## ADDENDUM NO. 2

Date: April 23, 2015

Project Name: Alberta Revitalization Infrastructure Project Phase 1B  
for the City of Tuscaloosa

City Project Number: A12-1324  
WA Project Number: 12-100

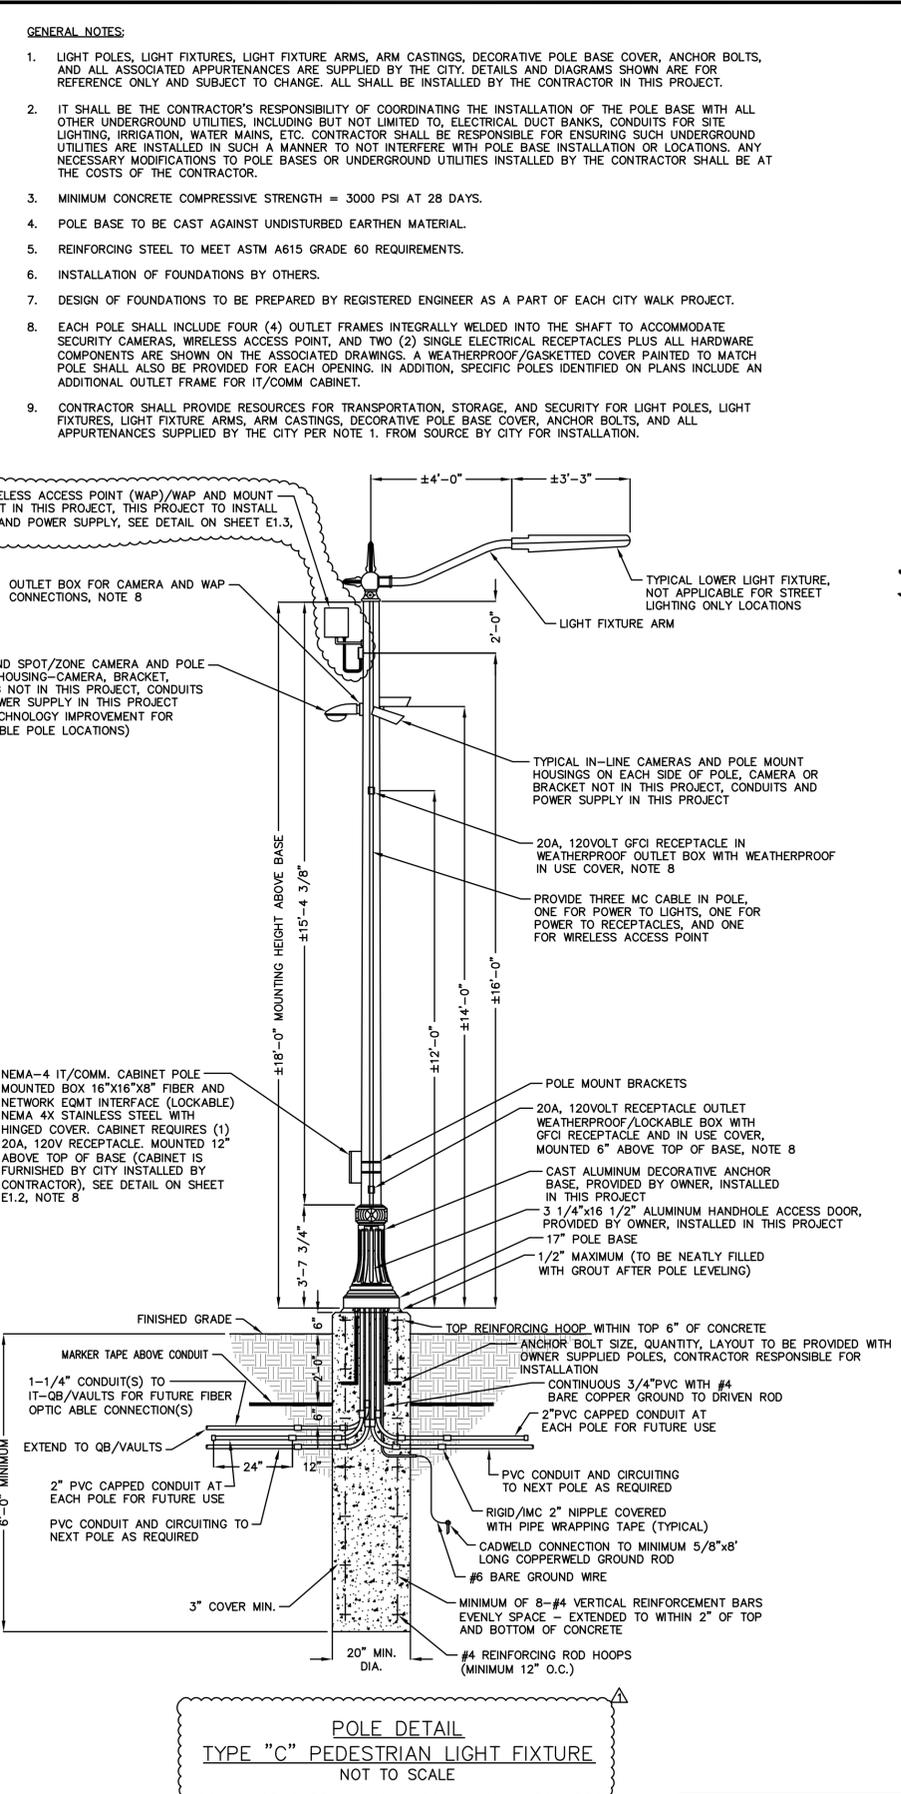
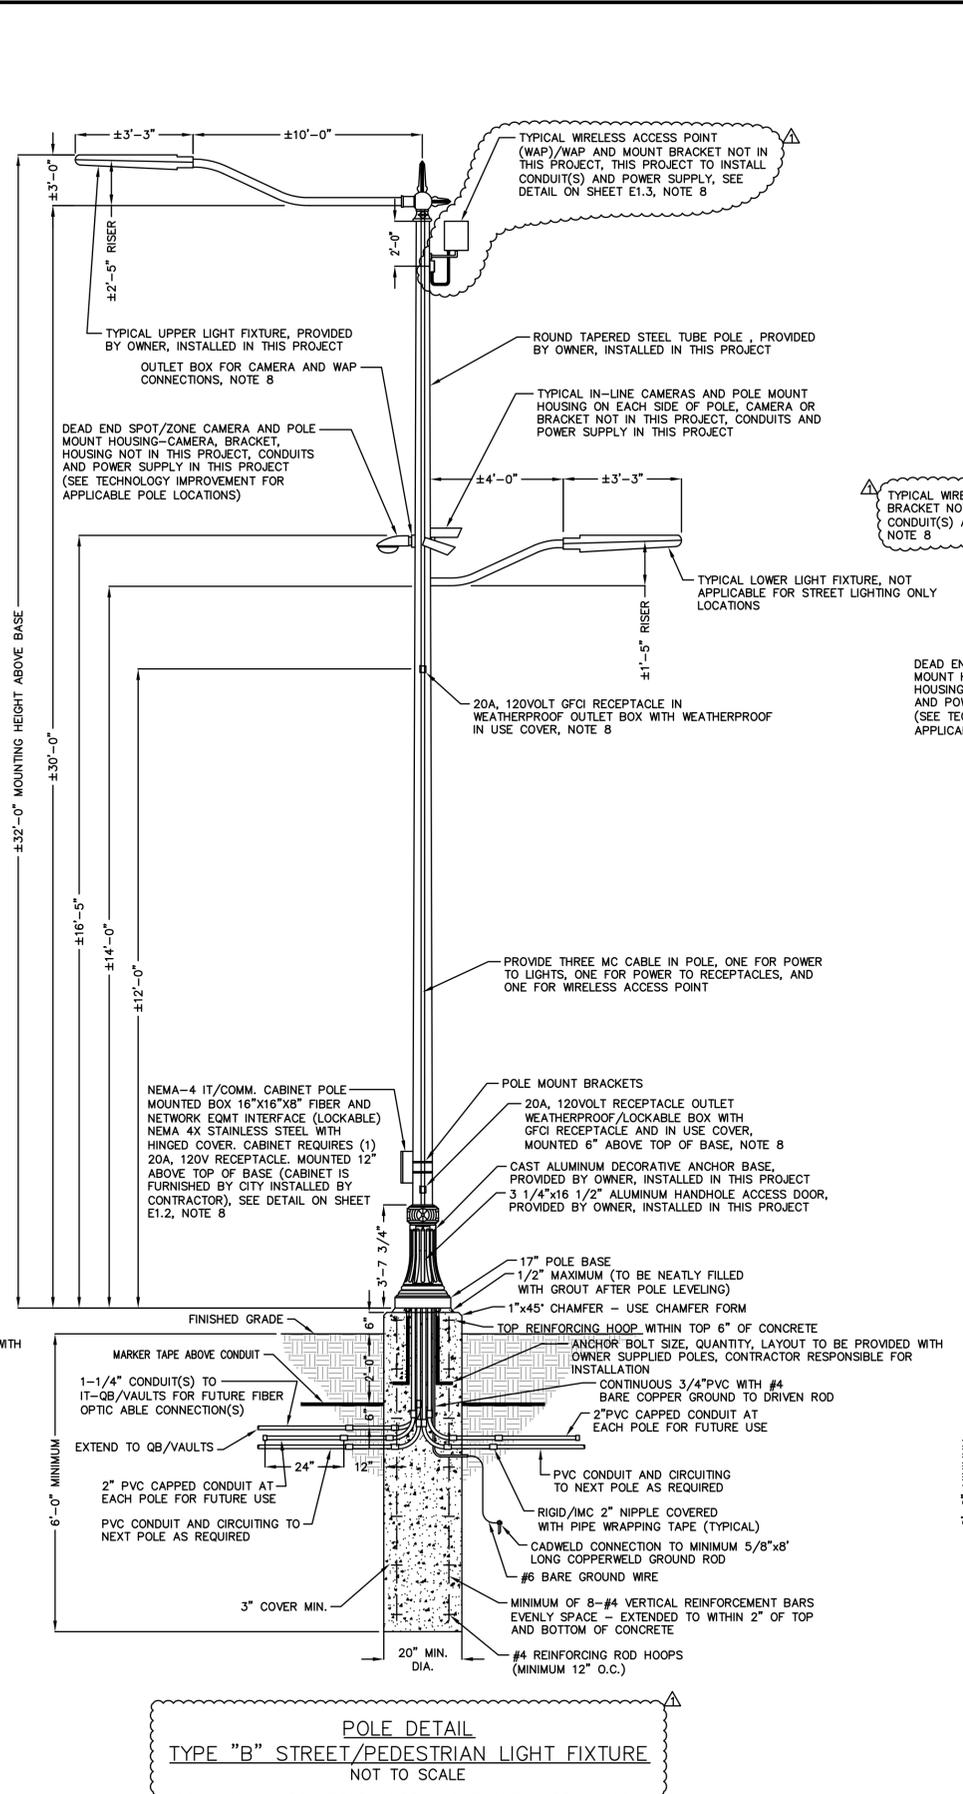
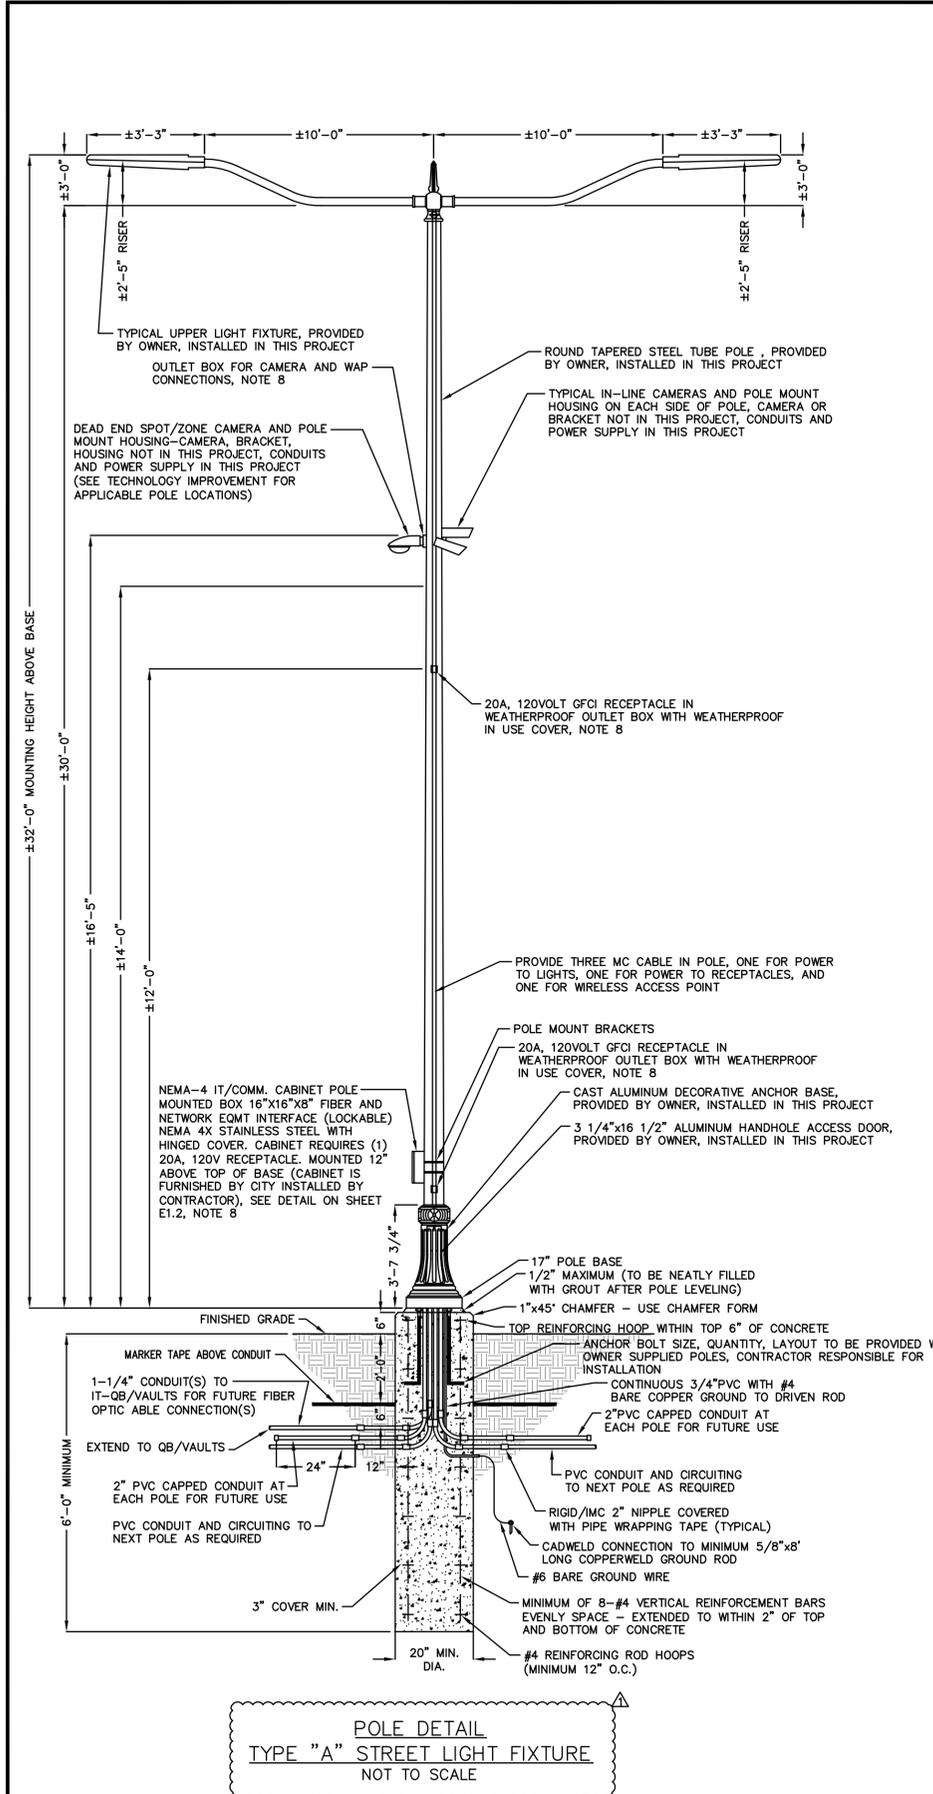
6. Drawing E1.1, General Notes #1, reads that light poles and fixtures....and all associated appurtenances are supplied by the City. Based on previous similar City projects there are several items shown on the detail that did NOT come with the poles when ordered and therefore are NOT supplied by the City. Can you please clarify the following items on these poles as being provided by the City or provided by the Contractor: GFI receptacles, Wireless Access Points, Cameras, Outlet Boxes for Cameras, IT/Comm Boxes and whether the boxes come with the GFI Receptacle as detailed.

7. Not every light pole will receive every item that is indicated on the pole details on drawing E1.1. Is there any way to quantify which poles receive which details. The reason this needs to be clarified is that the poles will be ordered to have openings on every pole for a device in every possible location. Knowing that not all of the poles will get a camera, IT Comm box, etc., there needs to be enough blank plates and bolts delivered from the pole manufacturer to blank off the openings that will not get used on certain poles. All poles will be ordered with the same openings, therefore, blank plates will be needed for each opening that does not receive any attached equipment. The Electrical Drawings in the construction documents indicate the poles that will have equipment installed such as IT-Cabinets, Cameras and WAP's. Also, a pole schedule has been provided as part of this Addendum to further clarify the pole type and whether they will include Cameras and WAP's.

- *GFI Receptacles - Upper and Lower (All GFI Receptacles shall be provided and installed by the Contractor)*
  - *Dedicated Circuit and Receptacles for the IT-Cabinet Comm. Boxes & WAP Locations (Provided and installed by the Contractor)*

- *Wireless Access Points (Provided and Installed under a separate contract)*
  - *Cameras (N.I.C. - Provided and Installed under a separate contract)*

- *NEMA 4X- 5"x5"x3" Boxes for Cameras (N.I.C. - Provided and Installed under a separate contract)*
  - *NEMA 4X- 5"x5"x3" Boxes for Wireless Access Points (Provided and installed by the Contractor)*

- *IT-Cabinet Comm. Boxes (Provided by the City, Contractor to install. The IT-Cabinets do not come with a receptacle in them. The circuit and the receptacle in the IT-Cabinet shall be provided and installed by the Contractor).*

DETAIL - "C"  
NEMA 4X - 5"X5"X3" BOX W/  
SEAL-TIGHT (GRAY) CONDUITS  
FOR CONNECTIONS TO WAP  
N.T.S.

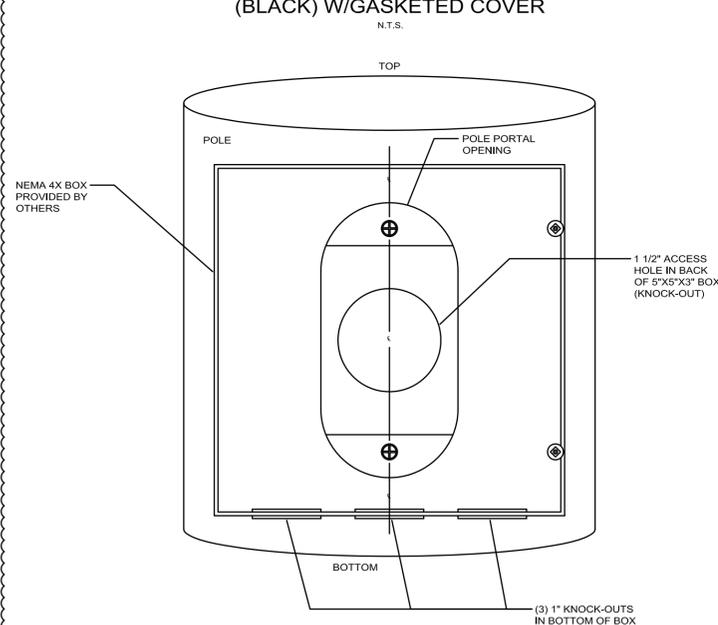
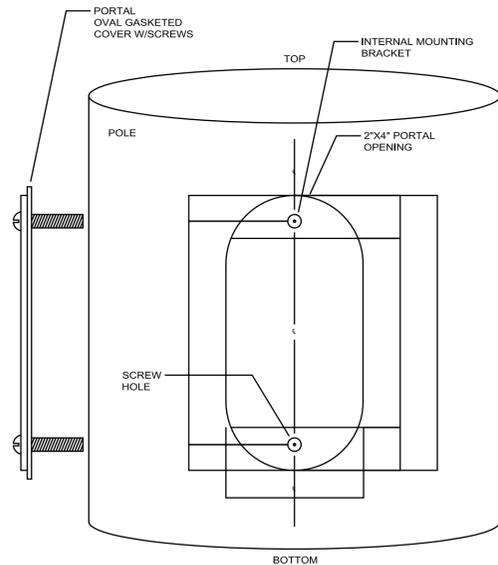
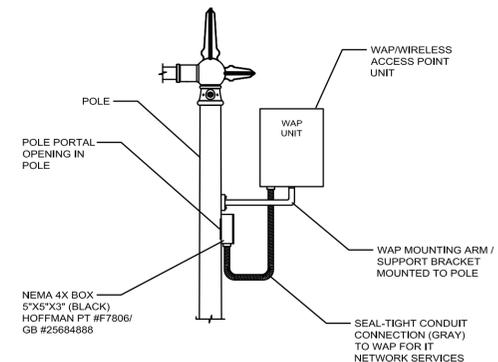
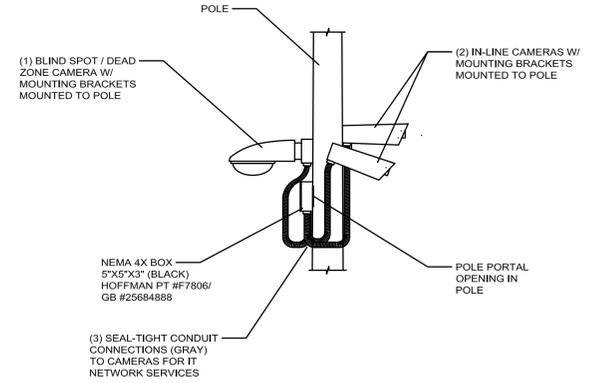
8. Can we clarify the size of the MC cables that need to be installed inside the poles for power and wireless access? Also, if a particular pole does NOT receive a certain device, please advise if a MC Cable for that device will still be required. The MC Cable size can be 3/8", 1/2" and 3/4" as required for the electrical circuit connections. MC Cables will be used for all electrical circuits as indicated in the documents. If Seal Tight Conduit are used between the openings for technology connections (i.e. security cameras, wireless access points, and IT-Cabinet Box), the Seal Tight Conduit "MUST BE" attached to the low voltage NEMA 4X 5"x5"x3" Boxes in an appropriate manner.

- The data concerning the IT-Cabinet w/all hardware, Network Data Switches and Power Supplies, Fiber Patch Cords, CAT-6 Patch Cords in the IT-Cabinet, Seal-tight conduit connections from Camera Housings/WAP Housings to the NEMA J-Boxes and the Electrical Receptacle/Outlet and Ground Bar that are provided on this drawing are for information purposes only.

- The placement of all these items are being installed under a separate contract.
- The Installation of all NEMA J-Boxes, Fiber and LIU/FODPU, CAT-6 Station Cable and Termination Box, with all Mounting Hardware are the Fiber Infrastructure-Vendor/Contractor's Responsibility.

- All Fiber and CAT-6 Patch Cords shall be provided by the Fiber Infrastructure-Vendor/Contractor. All Patch Cords will be provided to the City of Tuscaloosa, stored in the Main IT-Comm. Center for each of the CityWalk Project Sections. The installation of the Patch Cords will be completed by the Data Network, Security/Camera Network and Wireless Network Vendors/Contractors for installation.
